Addendum 1

**Columbus County Transportation
Whiteville, NC**

ADDITION TO COLUMBUS COUNTY
TRANSPORTATION CENTER
WHITEVILLE, NORTH CAROLINA

P-2

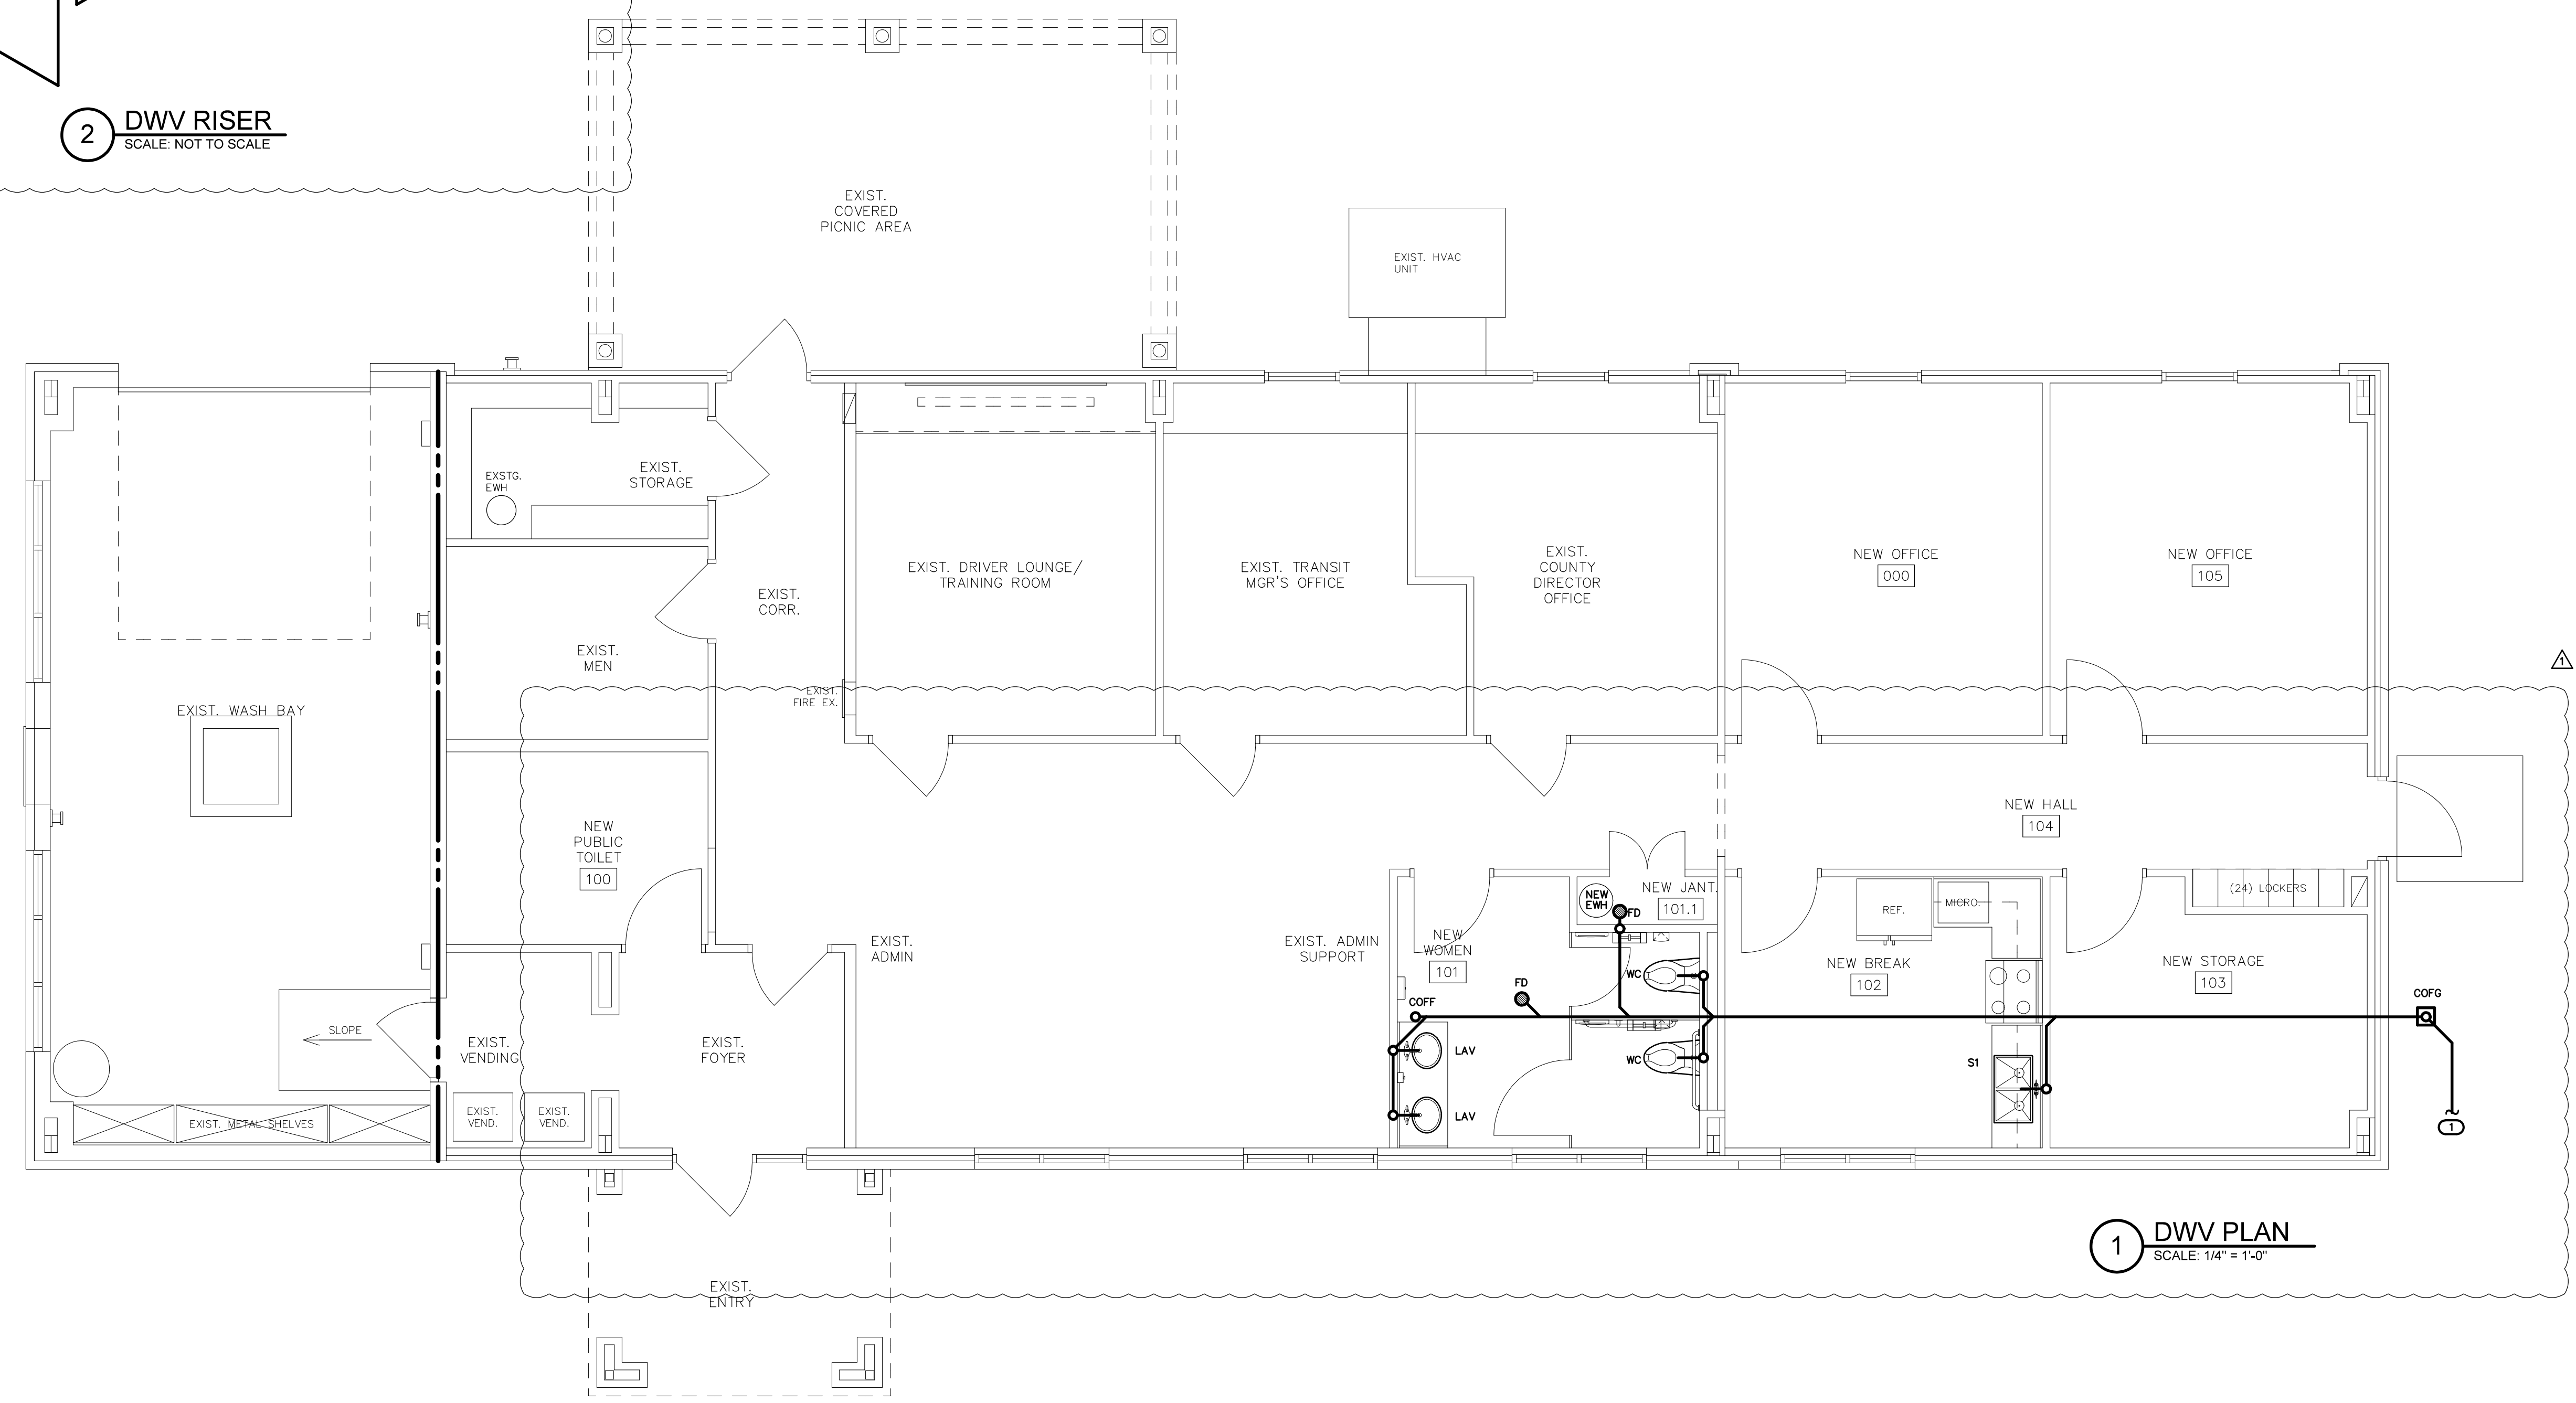
- See attached Revised P-2.
- See attached BD-1 for electrical work required for card access. G.C. to prep frame as required for card access to tie into existing system. Card access hardware to be a part of the hardware allowance.
- Clarification: All vinyl cove base to be 4" vinyl cove base (0.125" thick) with prefabricated corners.
- See below for the link to the US Department of Labor for Davis Bacon Wage determinations.
